Appendix K: Phase 2 Comments and Responses  
Attachments

Figure 1

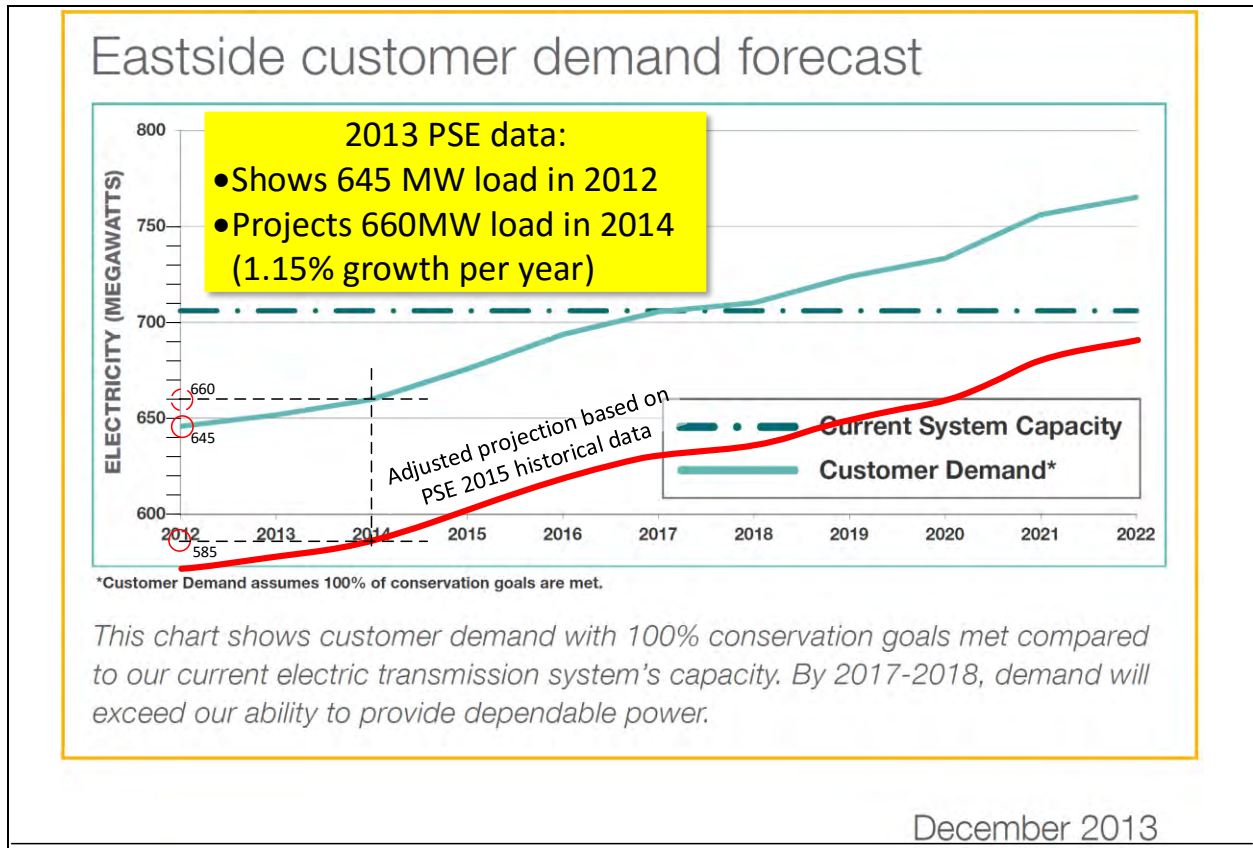
As cited above *“PSE’s Eastside Needs Assessment was conducted in accordance with industry standards for utility planning (Stantec, 2015)”*. In 2014 PSE advertised figure 1 (published in 2013) to the Community Advisory Group (CAG) as their demand forecast presumably based on the *“industry standards for utility planning”* PSE claims to follow. Their planning projected a demand of 660 MW in 2014 with approximately 1.15% demand growth per year between 2012 and 2014.

In 2015, PSE shows 2014 demand was 585 MW per figure 2 (published in 2015). This is a 5% per year decrease, not the PSE projected 1.15% increase. Why does Bellevue ignore this discrepancy in forecasted demand increase versus forecasted demand increaser?

Figure 2

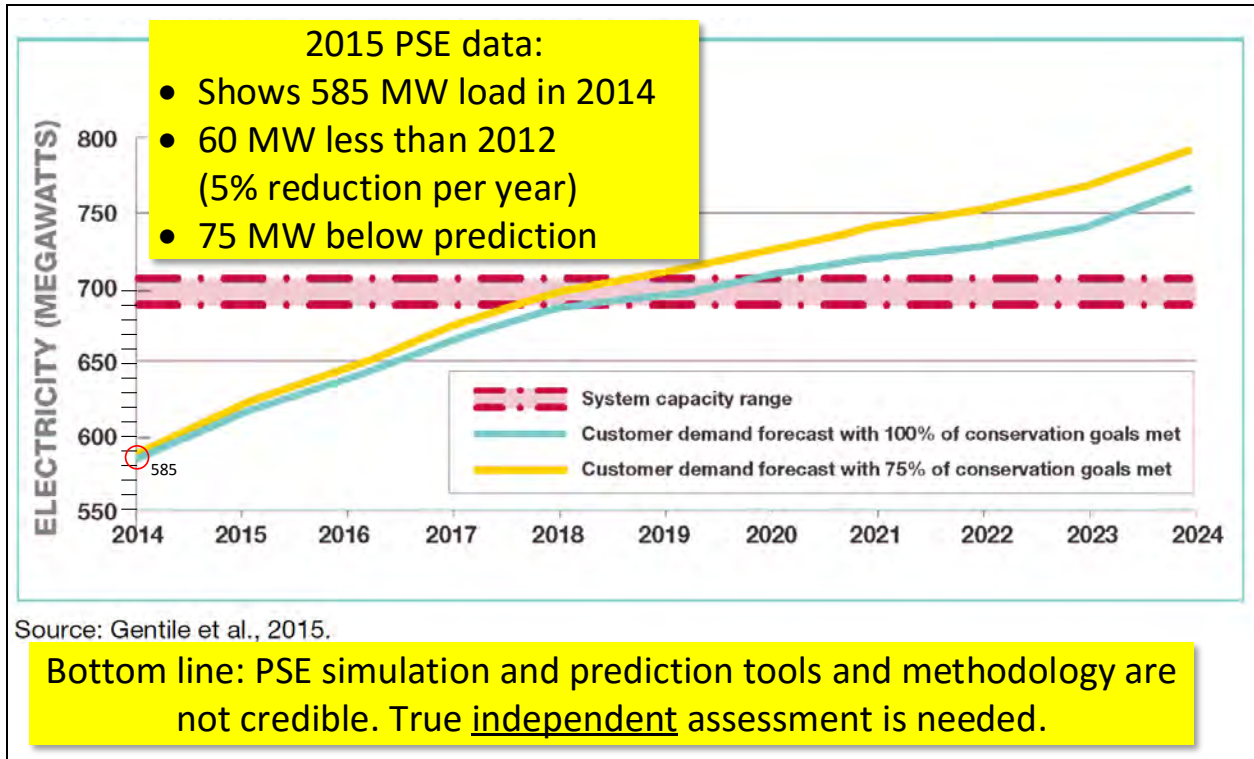
Besides revealing PSE’s huge accuracy error, the completely different 2015 forecast from PSE based on the same “industry standards for utility planning” shows a wildly different projection.

Accuracy and precision are both important qualities of a statistically significant measure or estimate. Accuracy is the proximity of a measurement and the actual value. Precision is the repeatability of a measurement. Figure 3 is an overlay of the two PSE forecasts published in 2013 and 2015. PSE’s own data shows forecast are both wildly inaccurate and wildly imprecise. Although based on the “industry standards for utility planning” PSE’s forecasts are essentially worthless as support for PSE’s energy shortfall claims. Why does Bellevue state these worthless claims as fact?

Figure 6

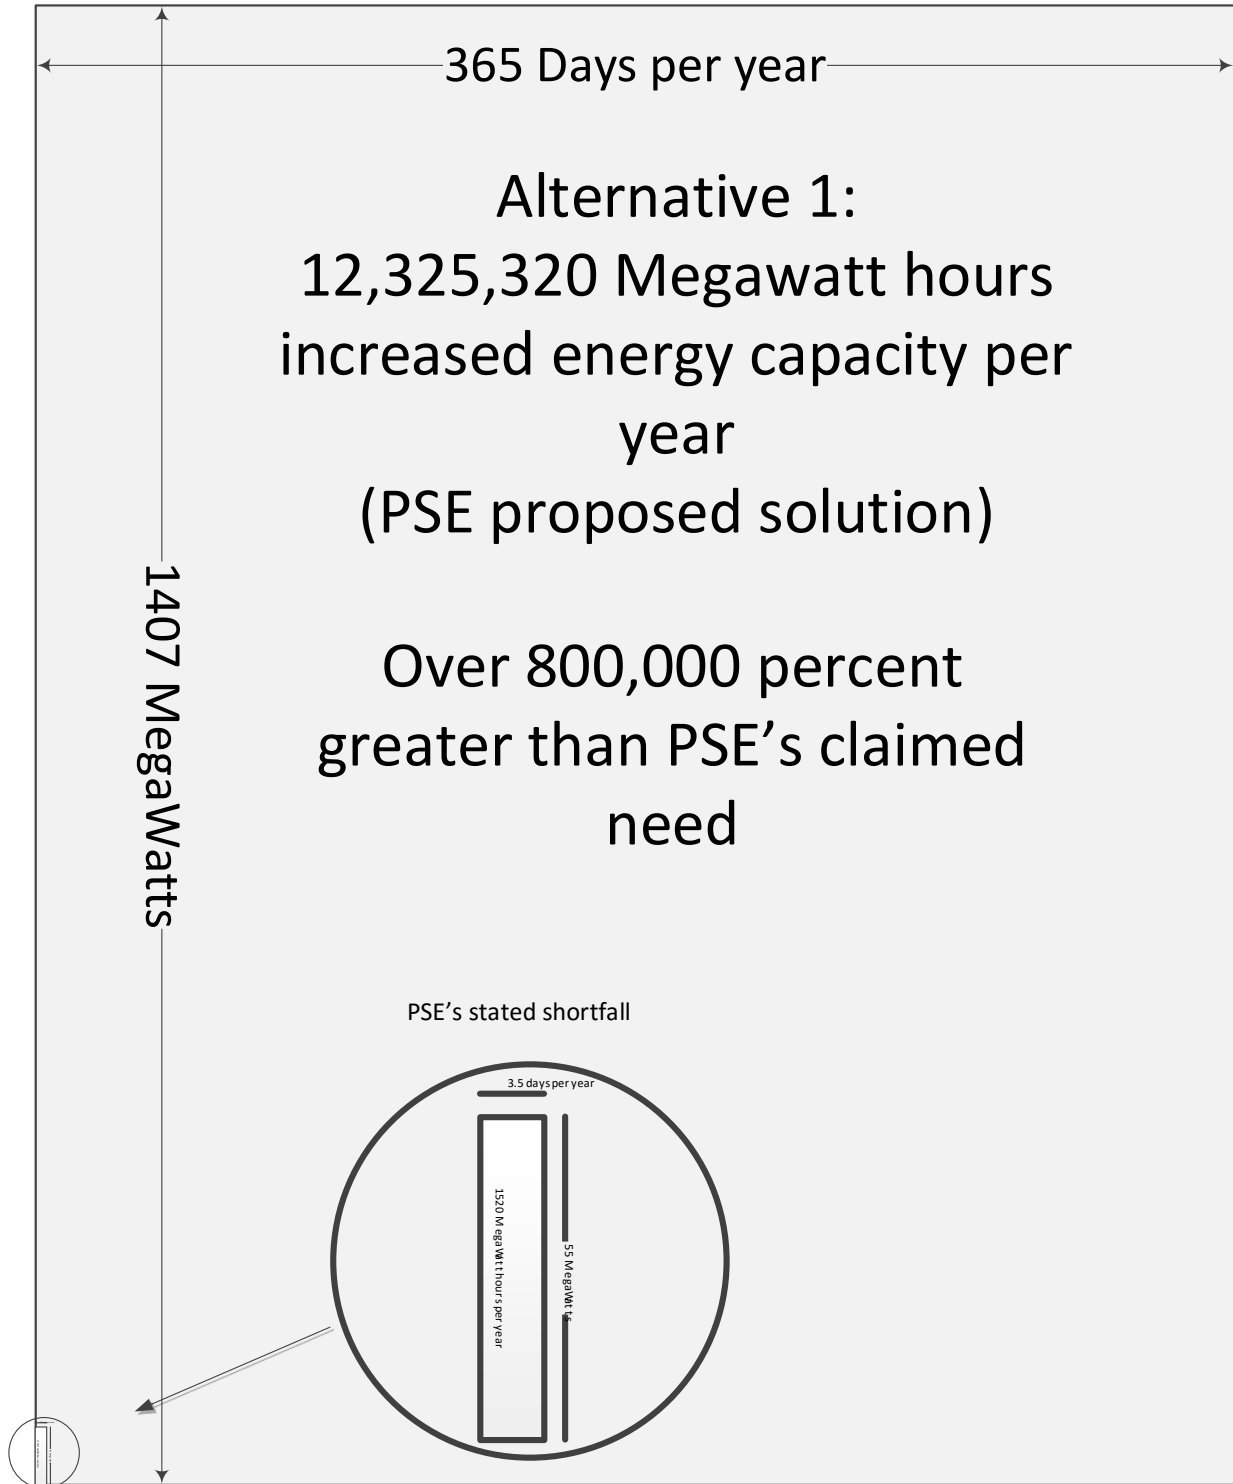
Figure 6 shows the relative scale of PSE’s proposed project vs PSE’s statement of need during the CAG process.

Why does Bellevue believe such an absurdly large growth in capacity is needed while rejecting more reasonable alternatives?

Figure 8

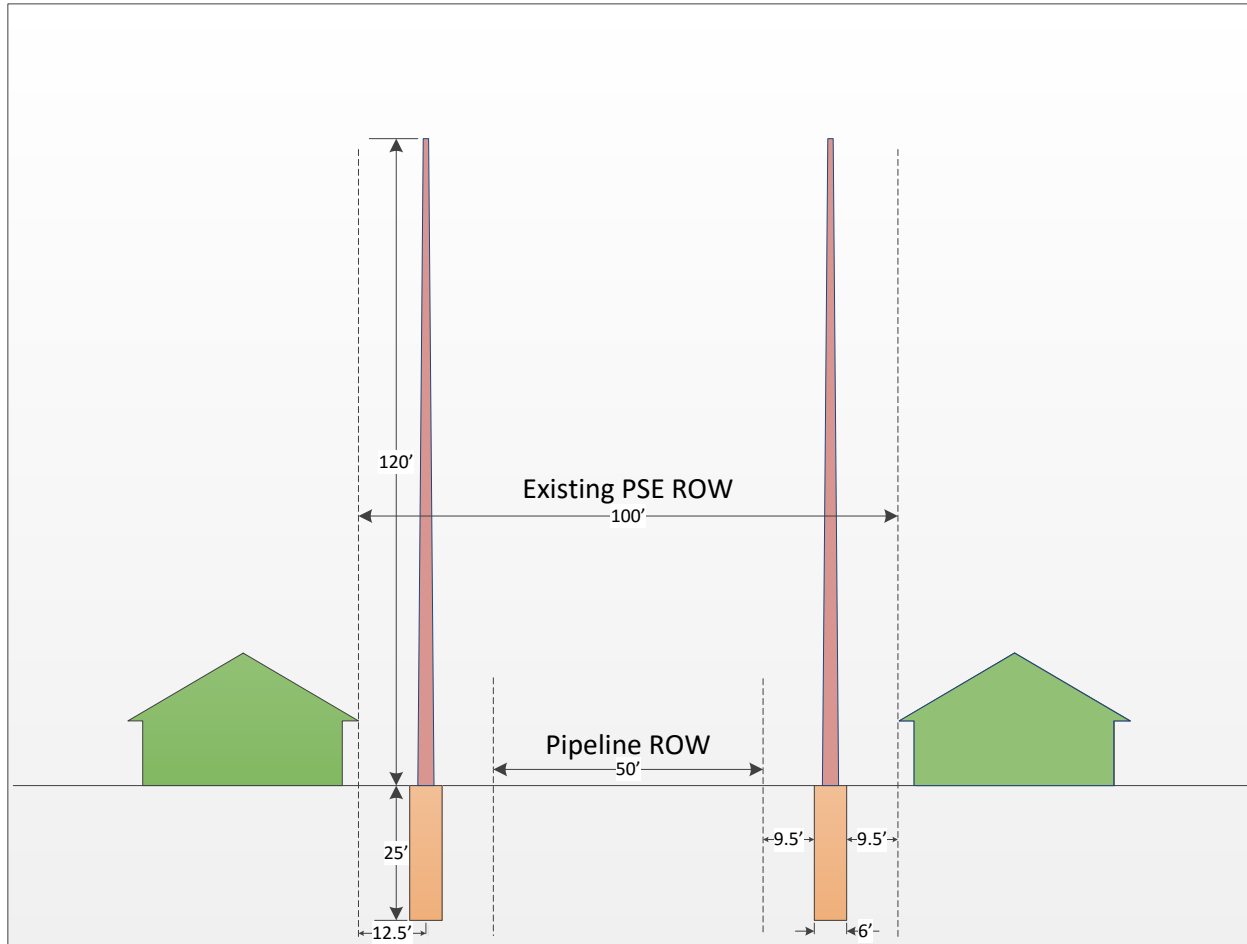
Figure 8 shows the nominal location of 120-foot-tall monopole towers on 6-foot diameter footings to support the proposed 230kV lines. The footings must be placed in undisturbed soil to be able to withstand lateral forces on the monopole. A minimum margin of undisturbed soil around the footing is required and must be within the PSE power line ROW. As can be seen, the footings can only be located within the outer 25 foot margins of the 100-foot-wide PSE power line ROW without directly violating the hazardous liquid pipeline ROW. The edge of the footing is potentially within 9.5 feet of existing and future residential structures given the current 100-foot-wide easement. This is far too narrow.

Figure 9

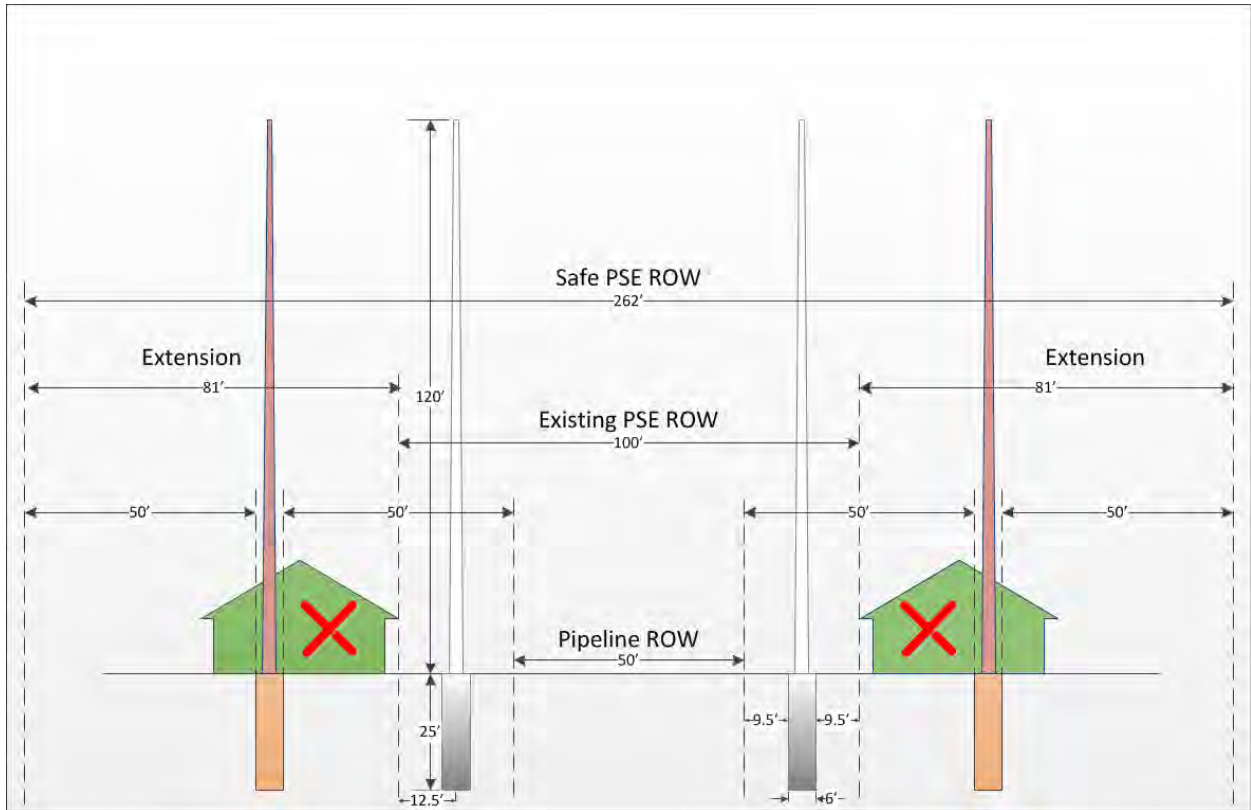
Figure 9 shows the proper extent of a 230kV power line ROW adjacent to a pipeline consistent with BPA standards. Although not as rigorous as other U.S electrical power industry standards it does present a moderate safety solution. As can be seen, the existing ROW has insufficient width to accommodate the proposed 230kV power line. Clearly, the application of common sense modern standards precludes the routing of the 230kV power line through route 'M' within the existing corridor.

The EIS must address the impact of implementing this safety requirement. The transmission line corridor must be wide enough such that no tower will be within 50 feet of pipes including utility, hazardous liquid, or residential pipes. The current corridor is 100 feet wide. It must be expanded to approximately 260 ft (2.5X) to ensure adequate safety. In addition, no tower should be located such that it is within striking distance of any structure subsequent to a structural failure of the tower. The EIS must address this impact.
